Delegated Report		Analysis sheet				Expiry Date	
						Consultation Expiry Date	
Officer				Application Number(s)			
Jessica McDonnell-Buwalda				2022/4101/L			
Application Address				Drawing Numbers			
The Logs 20 Well Road London, NW3 1LH				Design and Access/Heritage Statement; Site location plan; Existing Adjoining Elevation from No.19; Existing Garden Elevation from No.18; Existing Garden Elevation; Existing Front Elevation; 477-(101-104)_DG Proposed; 477-(550-551)_Window Details			
PO 3/4	Area Team Signature	C&UD	Authorised Officer Signature				
Proposal(s)							
The proposed works are for the replacement of all 18 windows with 22mm thick (6-10-6) argon filled double glazing in new timber frames units.							
Recommendation:		Refuse Listed Building Consent					
Application Type:		Listed Building Consent					
Conditions or Reasons for Refusal:		Refer to Draft Decision Notice					
Informatives:

PROPOSAL

1935

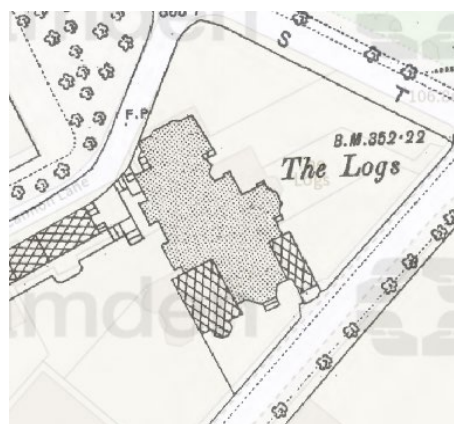
The DAS notes that the subject area of works is to a “1952 addition to the original house constructed on the site of the demolished conservatory.” Further analysis and research disproves this estimated 1950s construction date, where the subject section of the building footprint is shown in the 1935 OS Historic Map.

While the subject joinery does not date from *The Logs* original c.1876 construction, the 18 existing c.1935 windows are integral historic fabric associated with the progressive development of the building, and the significance of the subject window joinery has therefore been inaccurately assessed in the DAS, contrary to NPPF paragraph 194.
